RE: Bendigo-Ophir Gold Mine - Air Quality Technical Review

Bendigo-Ophir Gold Project: Assessment of Environmental Effects from the Discharge of Contaminants to Air Peer Review Report

Figure 1: Location of Annual Herbs (extract from Section 8.5 (Figure 33) PDP, 2025)

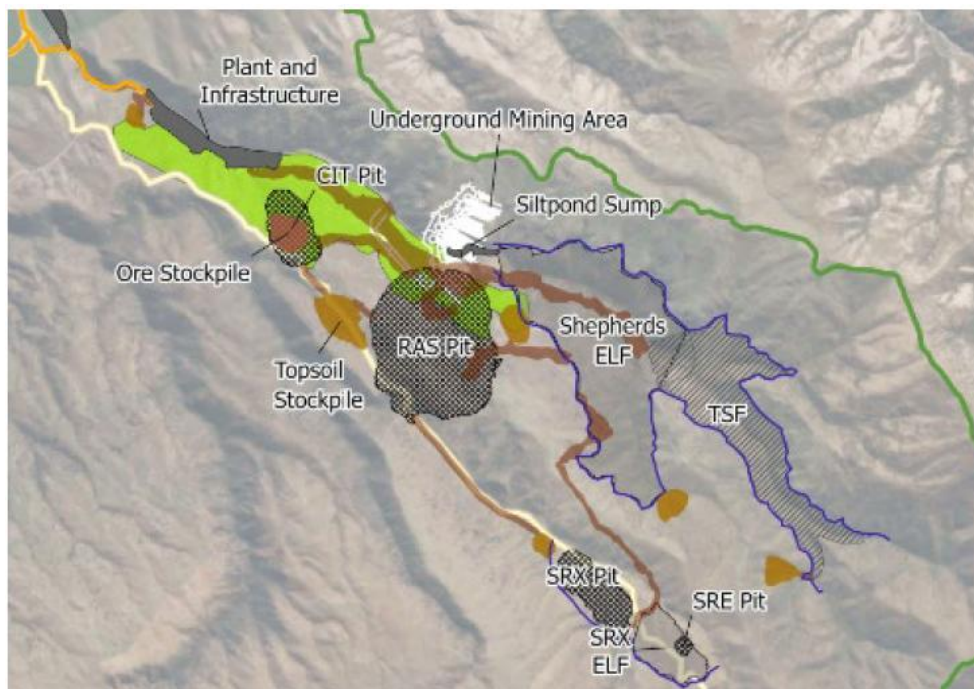
SLR has assessed the PDP (2025) ecological impact assessment as reasonable based on the dust loading, vegetation type and rainfall within the area. In fact, the assessment is likely

conservative given the vegetation type being an annual herb. With annual herbs having a lifespan of less than one year (approximately 9 mths) and dust not having long periods of time to accumulate on leaves, the dust impacts are likely to be less than those stated in PDP (2025). A potentially greater threat than dust to the annual herb population is clearing more impact assessed and sediment runoff from cleared and stockpile areas. The management controls associated with these issues should be managed as 'critical controls'.
